July 16, 2020

Acoustical Analysis Peer Review DRAFT

Cortona Drive Battery Energy Storage System

Figure 10. Fans Only Noise Sound Level Contours at 16 ft Elevation with All Fans Running at 40%

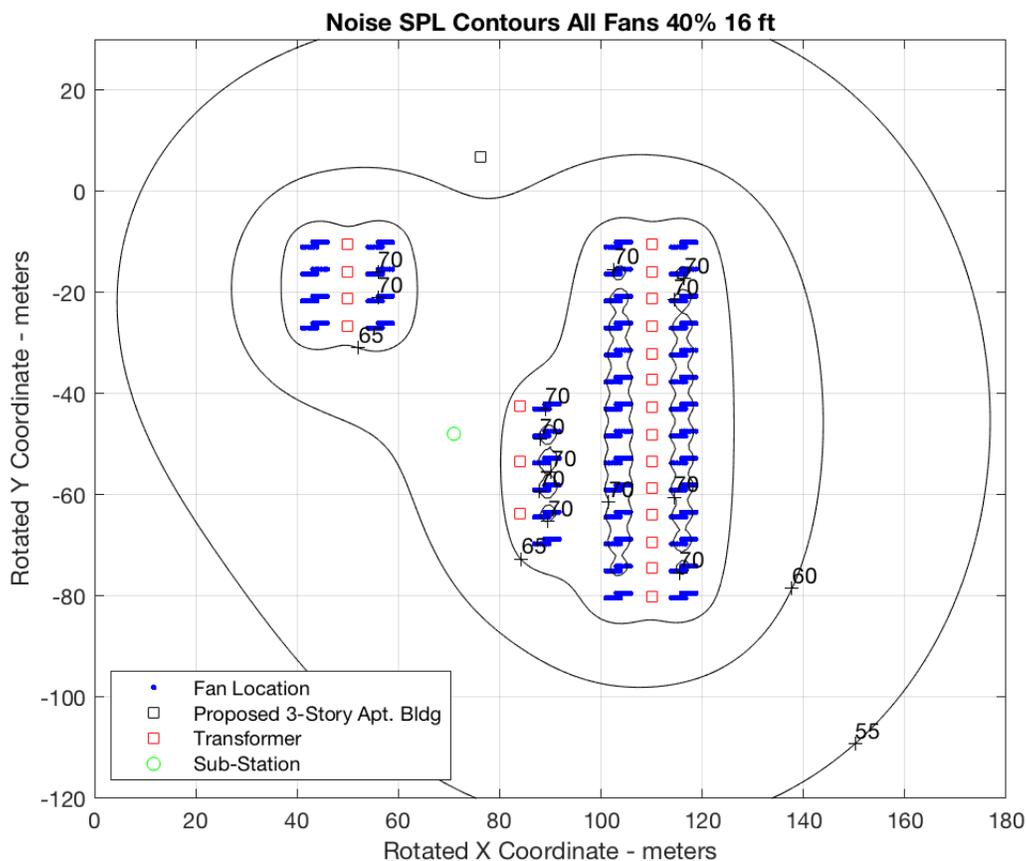
Transformers and the Sub-Station have been included in the Report noise modeling and appear to have a dominant effect in some directions. The fan noise alone, with all fans running at 40%, has been computed at 16 ft elevation with result as shown in Figure 10. It results in approximately 59 dB at the location of Building 6, which would be taken as 64 dB with a 5 dB tonality penalty applied. If the fans never actually run simultaneously, the off-site sound level could be estimated as $59 \text{ dB} - 10 \log_{10}(\text{fraction of fans running})$. The considerable difference in shape between Figure 10 and Report Figure 7 likely results from contributions by the sub-station and transformers, although the difference in shape of the 65 dB contours near the corners of the Megapack arrays is puzzling, and also be related to the number of fans assumed operating in the time period for which L_{eq} was being computed. It is very likely that noise emitted by the sub-station and transformers is tonal in character, but no data has been presented to allow investigation.

Figure 11. Approximate (unshielded) Noise Contours for All Fans, Transformers and Sub-Station

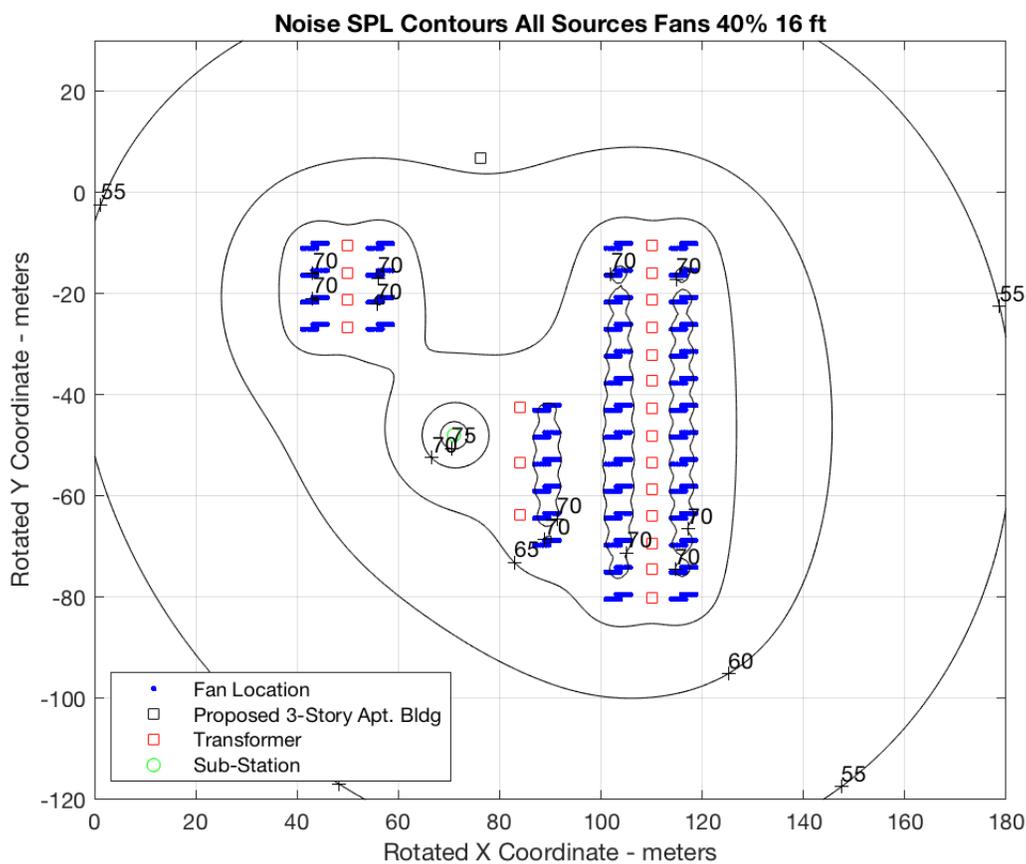
As a check on the effect of the transformers and sub-station, Figure 11 shows the approximate effect of adding them to the fan noise. At the nearest apartment, the total is raised about 1 dB, to just below 60. The contour shapes indicated in the Report could not be duplicated, possibly due to the Reviewers simpler model not including the shielding and reflecting effects of buildings or the Megapacks.

4. The project should include a contingency for installing sound-attenuating treatments above the cooling fans on some of the Megapacks nearest the property line with Cortona Apartments. Sound barriers around the northerly side of some of the transformers and the noisy components of the substation may also be advisable.
